## NEW CONSTRUCTION STAGE PROPERTY INSPECTION REPORT AS4349.0-2007

Type of Inspection Completed	Pre-lining Inspection
Have Architectural and/or Structural Engineering Plans been provided for this inspection:	Yes
<p>It is the responsibility of you (the client) to provide us (the inspector) with a full set of construction and engineering drawings for us to compare the construction drawings to what is being built on site.          Without these drawing we can Not comment on incorrect home and room dimensions, specified levels, engineer specifications and any relevant Australian Standards that has been referenced for the project.</p>	
Prevailing weather conditions at the time of inspection:	Dry
In respect of significant items:	
Was there any MAJOR DEFECTS evident from this inspection?	Yes
Was there any MINOR DEFECTS evident from this inspection?	Yes

**Location:** Family room

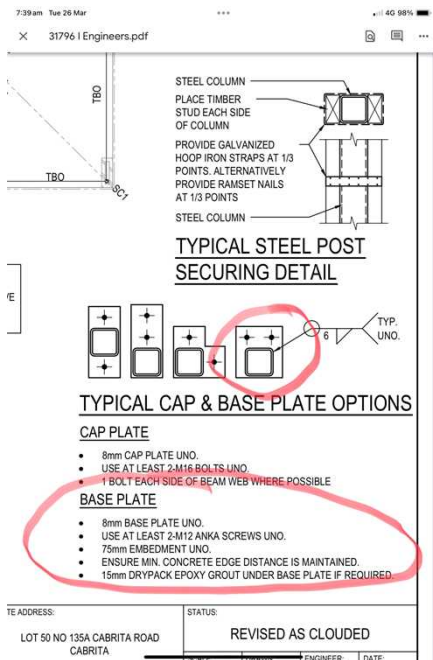
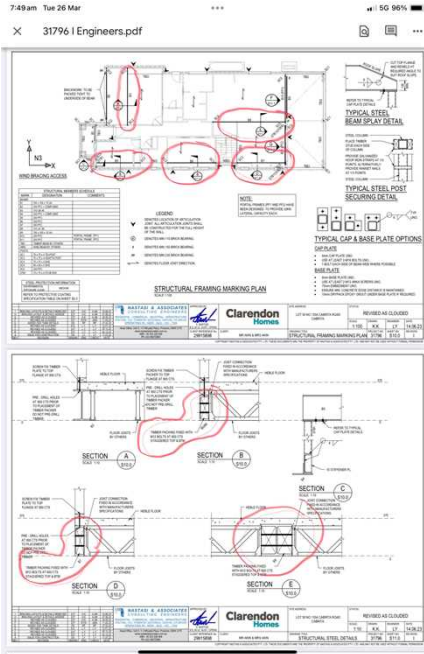
**Details:** The family room far corner adjoining the alfresco.

The alfresco beam which sits on the internal wall of the family room is out of alignment by 10 mm.

This will cause plasterboard to be pushed out and be out of plumb.

**Recommendation:** Alfresco beam to be adjusted by at least 10mm further out.

This will allow sheeting to be fixed straight and plumb.

**Location:** Timber packers to structural beams to ground floor.  
Marked on architectural in red for locations.

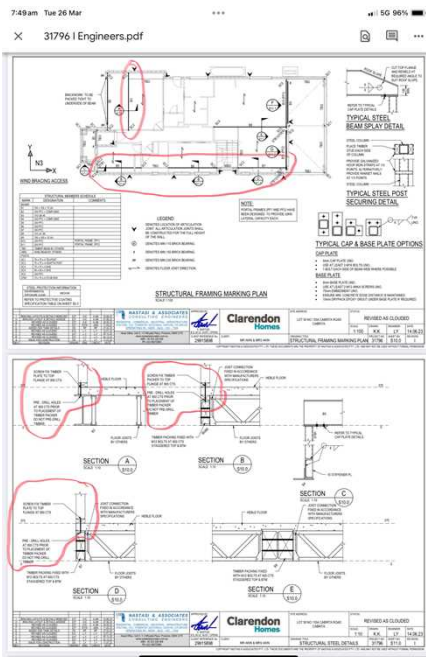
**Details:** Timber infills/packers are required to have m12 bolts at 600mm centres staggered top and bottom throughout all beams, as detailed in the engineers drawings.

This has not been completed to any of the beams.

**Recommendation:** This bolts must all be installed prior to any sheeting.

Evidence of each beam and fixings to be provided.

**Location:** First floor flooring.

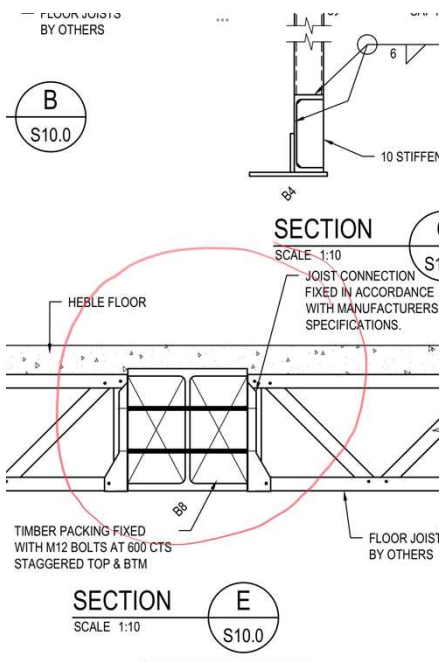
**Details:** Timber infill used for flooring above beam b8.

This is not the design.

This should have Hebel and be consistent throughout the flooring.

Yes I can see why this was done. The thickness of the Hebel would be 5mm to big approximately. This is shown in the engineers detail though?

The Hebel can be easily sanded, plained back.

**Recommendation:** Remove timber infill and install Hebel as per design.

**Location:** Flooring to bathrooms, ensuite.

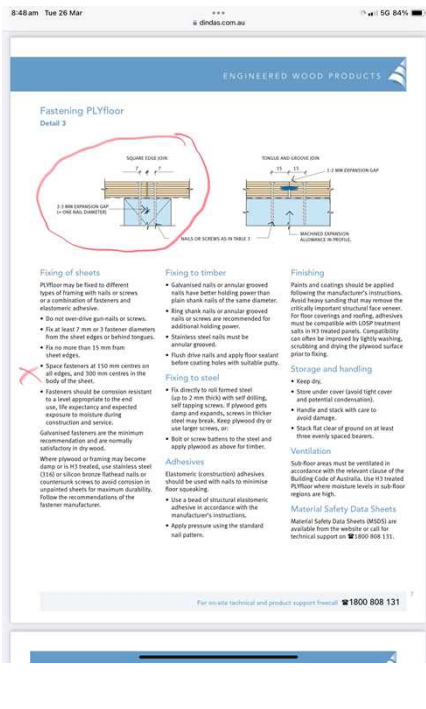
**Details:** Plywood requires fixings as would particle board flooring.

As per AS1684.2-2021 timber framing code

Clause.5.5.4.3 FIXING. Sheets to be glued and nailed to the top edge of the joists, Nails shall be 10mm from all edges and at 150mm centres at ends and 300mm max centre at intermediate joists.

Only amendment is plywood is not tongue and groove so requires end fixings 7mm apart.

Refer plywood engineer detail for flooring installation

**Recommendation:** All plywood flooring to have fixings added.

**Location:** Balcony door, window.

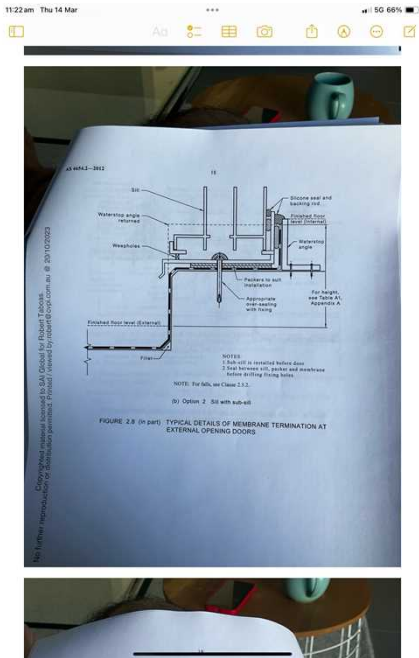
**Details:** The detail completed onsite will be difficult to make compliant with External waterproofing AS4654.2-2012

The flashing installed will need to fold down and the tile fixed over it. It is a very strange way to finish balcony.

Generally the waterproofing continues up the wall/floor joists and under the door with waterstop installed.

Please check images from AS4654.2-2012 in the following defects.

**Recommendation:** Clause 2.8.3 Doors and windows onto external waterproof areas.

A) subsill flashing shall be included as part of the membrane system

B) where the internal and external finished floor levels do not allow an upturn the membranes shall be fixed under the sill and terminate in the stormwater system.

**Location:** Balcony.

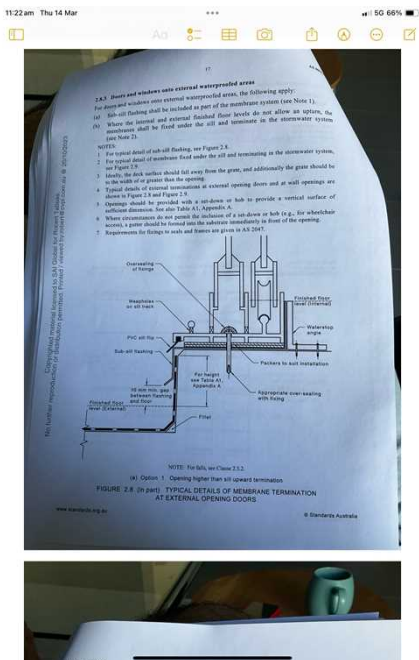
**Details:** Example of waterproofing details from External waterproofing AS4654.2-2012

**Recommendation:** Builder to provide further information on design and finish to door and balcony junction.

**Location:** All bathrooms, ensuite, WCs

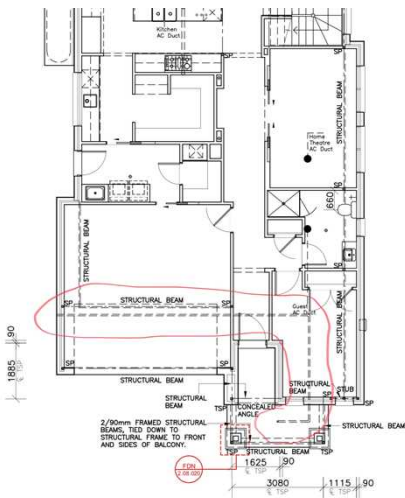
**Details:** Ensure all mechanical exhaust is roughed in and ducted to outside air.

**Recommendation:** 10.8.2 of NCC 2022 Exhaust systems.

- 1) An exhaust system installed in a kitchen, bathroom, sanitary compartment or laundry must have a minimum flow rate of
  - i) 25L/s for a bathroom or sanitary compartment and
  - ii) 40L/s for a kitchen or Laundry
- 2) Exhaust from a kitchen, kitchen range hood, bathroom, sanitary compartment, or laundry must be discharged directly or via a shaft or duct to outdoor air .
- (3) where a venting clothes dryer is installed it must discharge directly or via a shaft or duct to outdoor air

**Location:** Roof outside dining room.

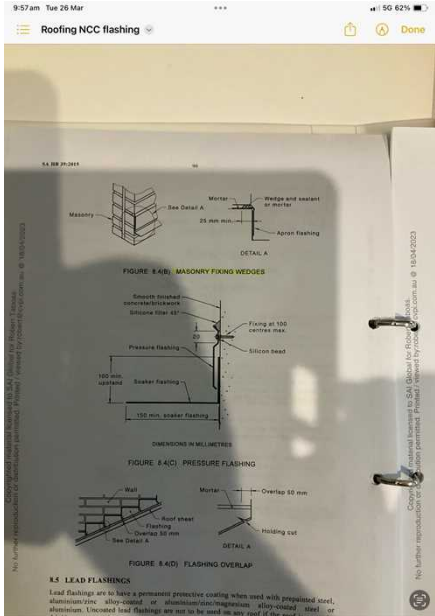
**Details:** The overflashing needs to be re-completed.

The flashing is insufficient length.

The flashing is not cut into the masonry.

Compression flashings are not completed like this I'd it is to be used.

As per the NCC

Clause 3.5.1.7 Flashings and cappings

V) wall and step flashing must be fastened into masonry walls with galvanised or zinc/aluminium sheet metal wedges at each end of each length and at intermediate intervals of not more than 500mm and must overlap by not less than 75mm in the direction of flow.

**Recommendation:** Re-complete this area

This area needs to be detailed and encourage Clarendon to check all flashing and cladding junctions.

**Location:** As per previous location.

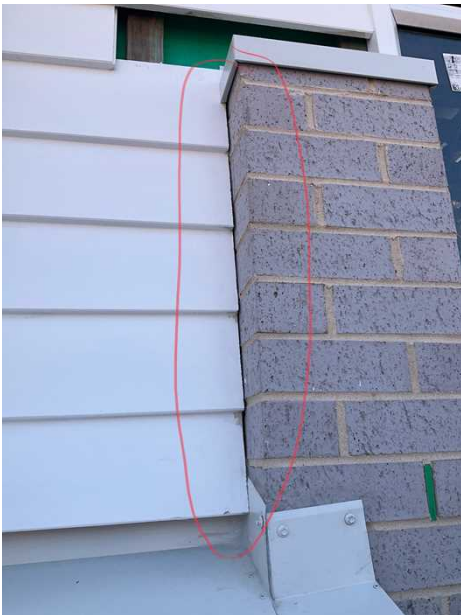
**Details:** Flashing must be lapped 75mm.

The flashing has been but jointed and siliconed up to provide a seal.

As per the NCC

Clause 3.5.1.7 Flashings and cappings

IV) joints in flashings and cappings must be not less than 75mm, lapped in the direction of the fall of the roof, and fastened at intervals not more than 40mm.

**Recommendation:** Flashings to be recompleted.

**Location:** As per previous, same location.

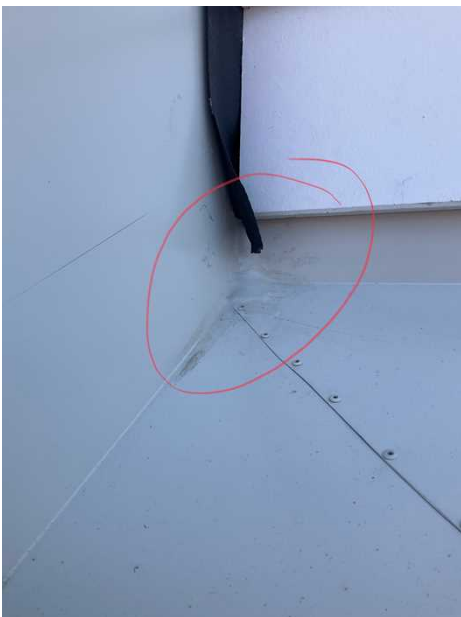
**Details:** Recommend Clarendon check with cladding manufacturer on cladding and brick junction requirements.

In our opinion it would be best to install angle flashing at this junction.

It may or may not be required pending manufacturing details.

Sikaflex joint may be suitable.

**Recommendation:** Clarendon to review flashing in this location.

**Location:** Exterior roof junction at guest and dining room exteriors,

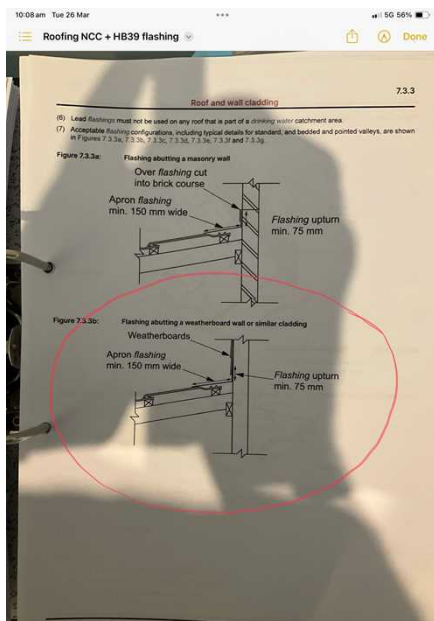
**Details:** Examples of flashing not lapped 75mm and but jointed, sealed with silicon.

As per previous this is a breach of the NCC metal roof flashing requirements.

**Recommendation:** Builder to review all flashings completed onsite.

The roof flashing work completed is not the usual Clarendon quality.
